November 4, 2024

SUBJECT: NEW VEHICLE DEMONSTRATION / DELIVERY HOLD - Safety Recall 24S61
Certain 2024 Model Year Explorer Vehicles with 3.3L Hybrid Engines
Tie-Strap High Voltage and Battery Cables

CERTAIN 2024 MODEL YEAR EXPLORER VEHICLES WITH 3.3L HYBRID ENGINES — TIE-STRAP HIGH VOLTAGE AND BATTERY CABLES

FIGURE 1

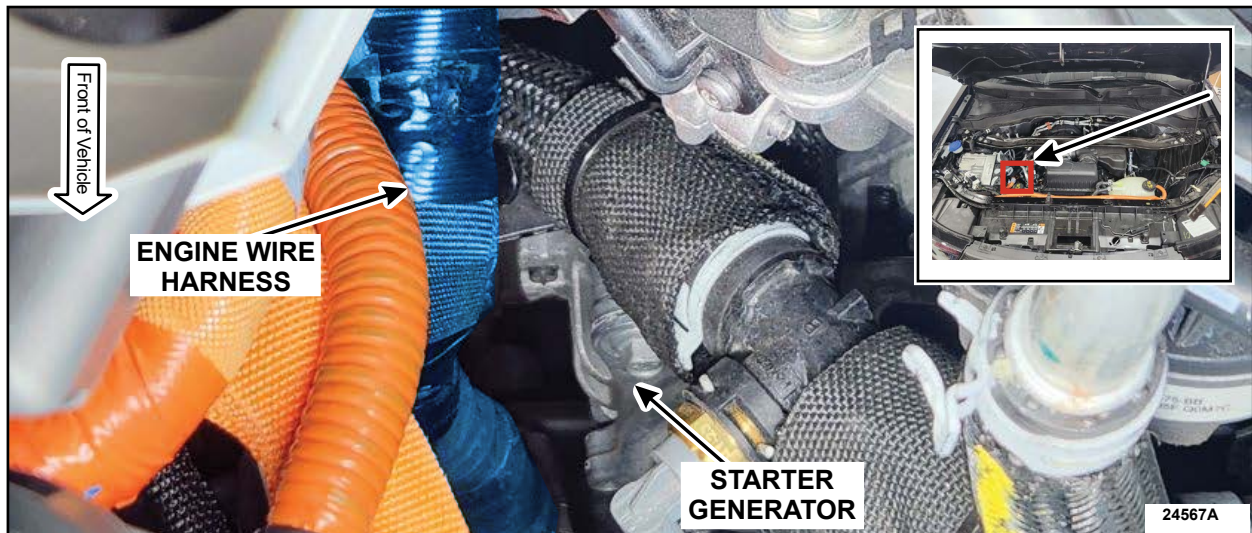
1. Locate and inspect the engine wire harness that runs next to the starter generator for any damage. Is the harness damaged? See Figure 1 for harness location.

- Yes - Contact the Special Service Support Center (SSSC) for further repair instructions.
- No - Proceed to step 2.

FIGURE 2

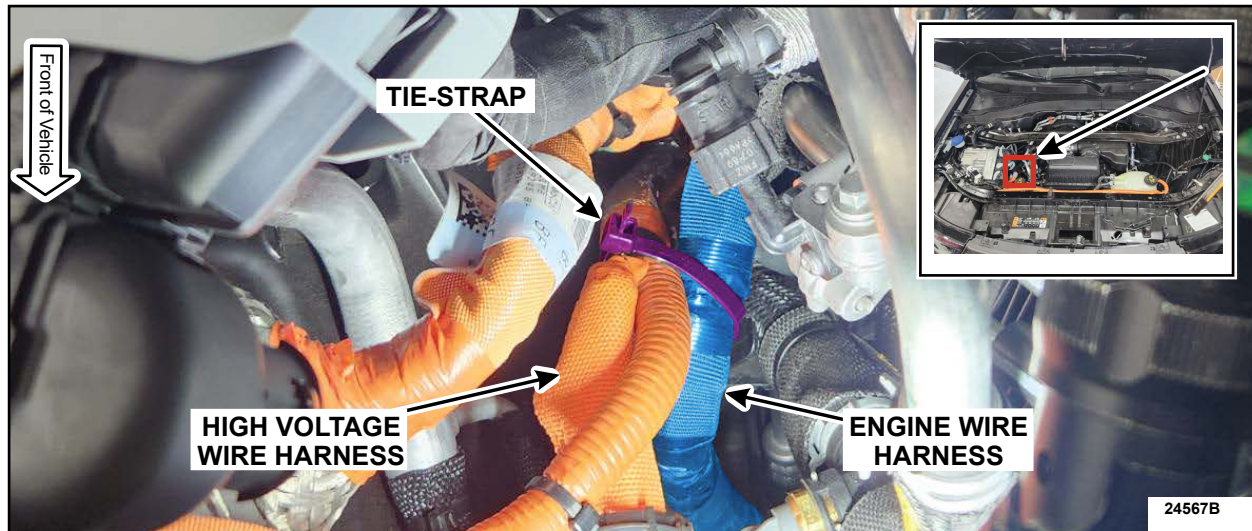
2. Using the specified tie-strap, secure the engine wire harness to the high voltage wire harness to ensure clearance to the starter generator as seen in Figure 2.
